**Automobili
Lamborghini S.p.A.**

Recall - Double wishbones

Campaign Code: L140-R.01.06 (Coupé)
Campaign Description: Gallardo suspension arms replacement
Cost Code: 60
Component Code: CCR0106
Trouble Code: 220
Labour code: CCR0106100
Labour Time: 9 hr

Top double wishbone (front axle):

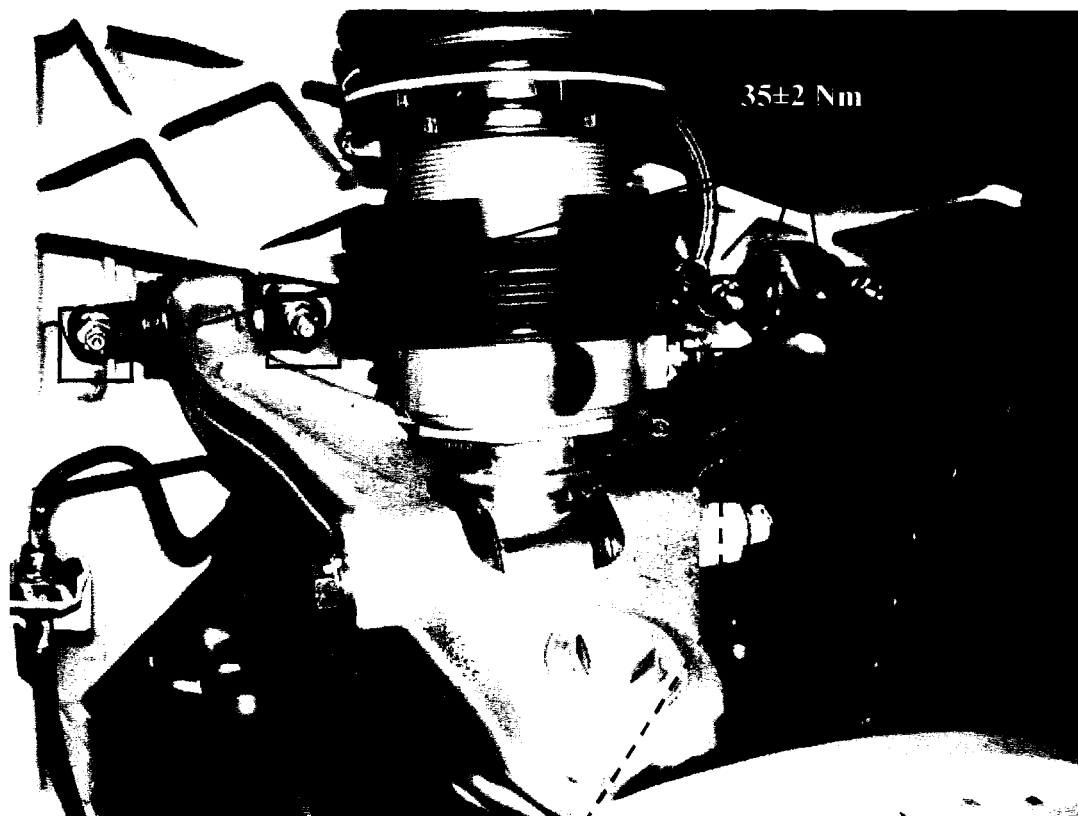
Nut No. 3 on drawing

Nut No. 1 on drawing

Nut No. 19 on drawing

Bottom double wishbone (front axle):

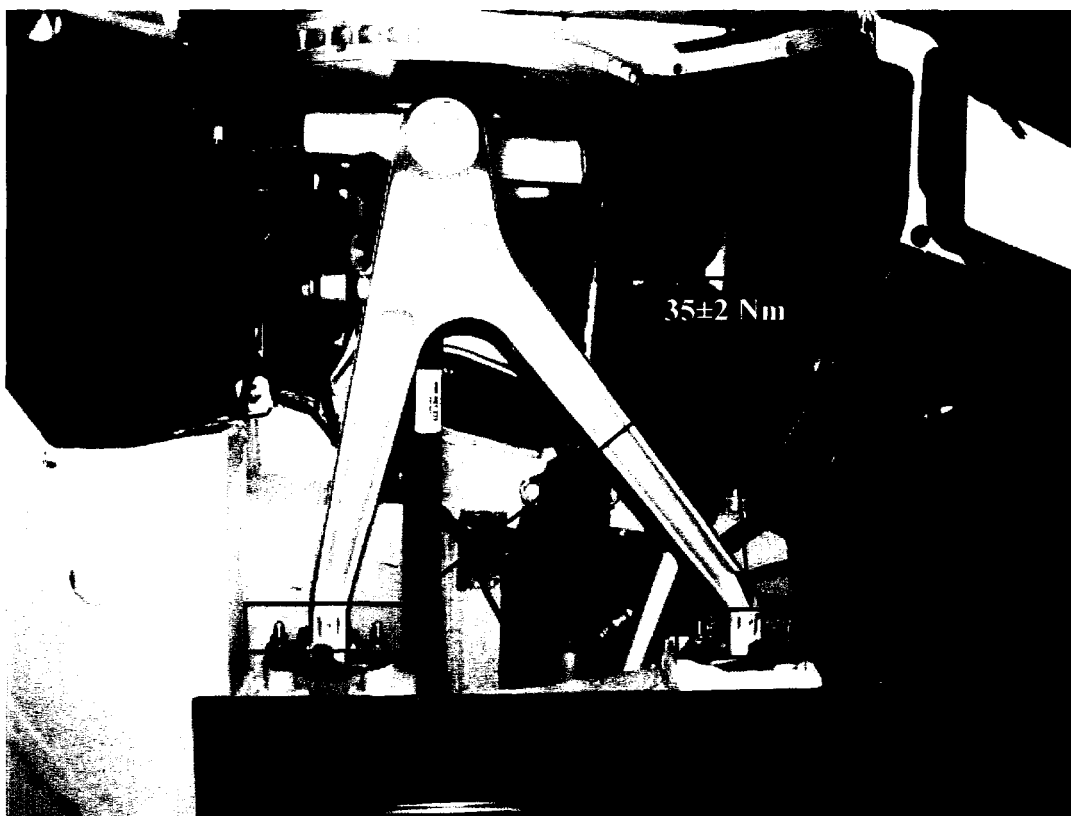
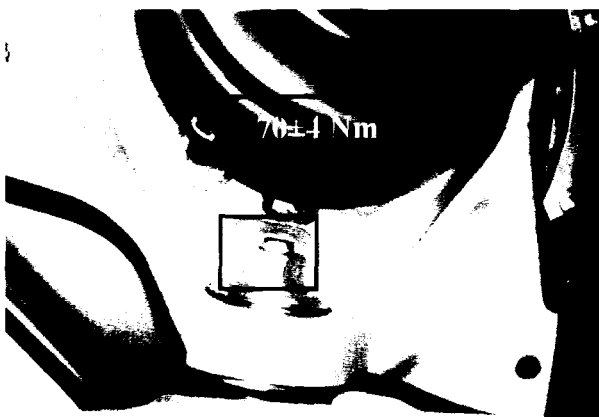
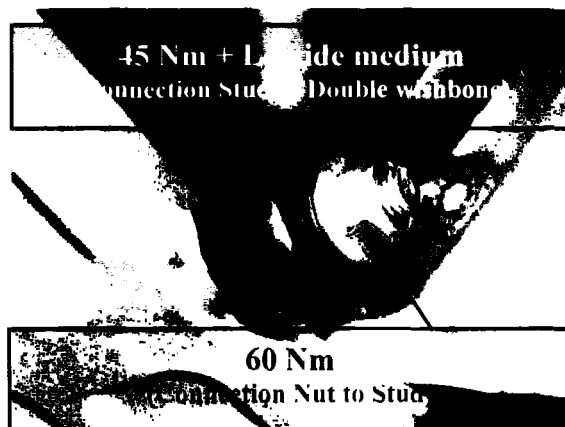
Nut No. 3 on drawing

Nut No. 19 on drawing

Connection No. 25 on drawing

Top double wishbone (rear axle):

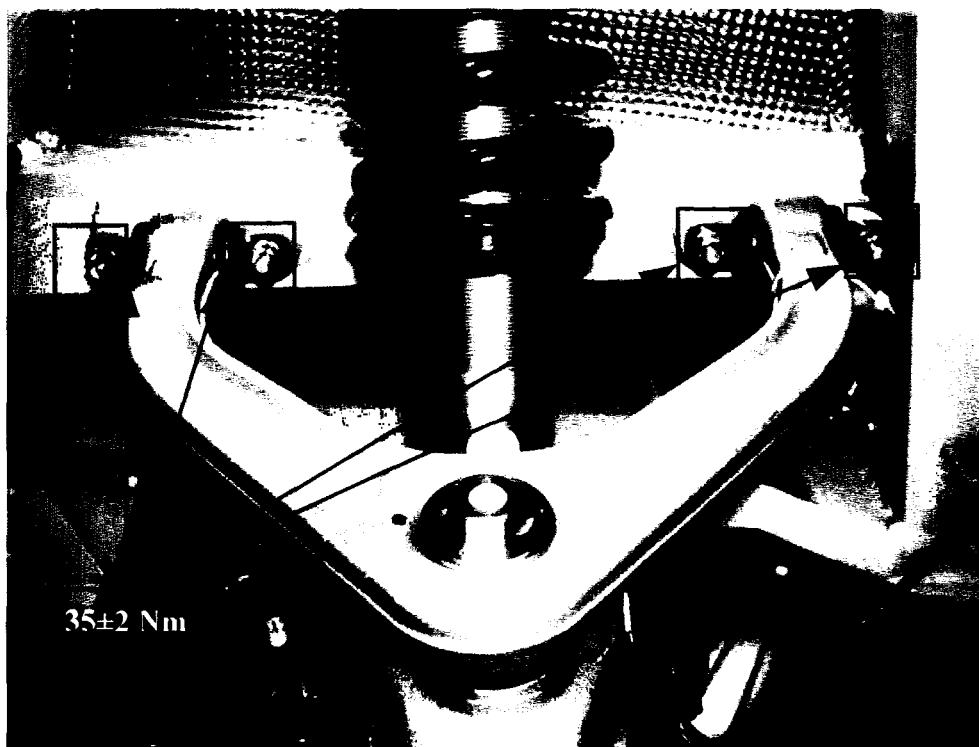
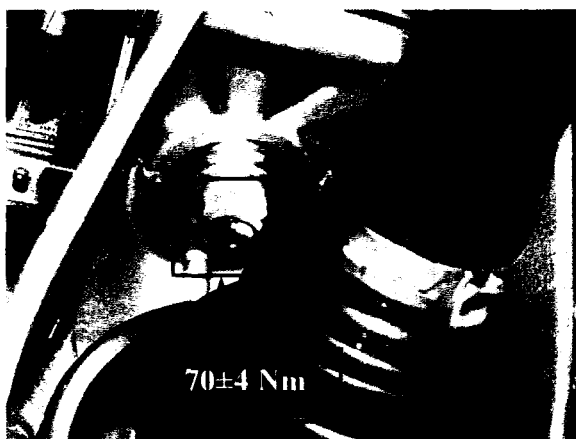
Nut No. 8 on drawing

Nut No. 4 on drawing
